Re: Colony Park flood plain permit  
application addendum (#101.3)

Floodplain Permit

CITY OF GRAND JUNCTION FLOODPLAIN PERMIT APPLICATION

Subject: Floodplain Permit Application for Colony Park

PROPOSED LOCATION OF  
PATH, DITCH AND PATTERSON  
ROAD ADJACENT TO  
COLONY PARK SUBDIVISION

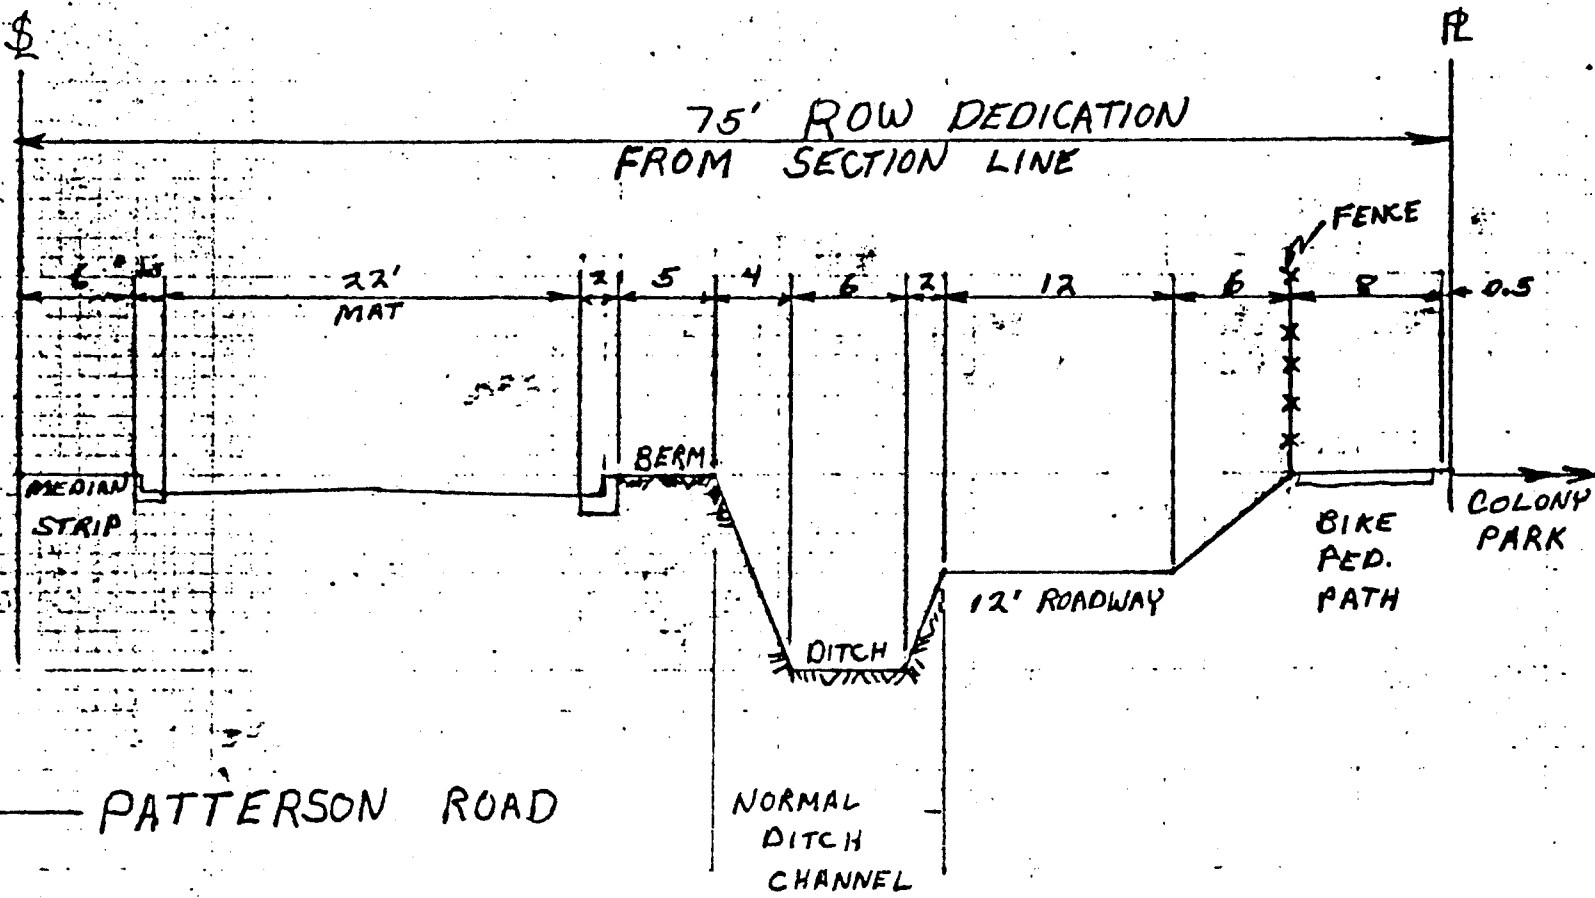
We do anticipate some channel work, as indicated on the typical finished cross sections contained herein. This proposed section is general only, as we intend to correlate this work with the development of Patterson Road. Channel size will not decrease and the removal of the obstructive crossing will keep the 100-year flood out of Colony Park.

The typical improved ditch channel included in this report is adequate to safely handle the 100 year flood flow and has been correlated with the City's planned "F" Road improvements.
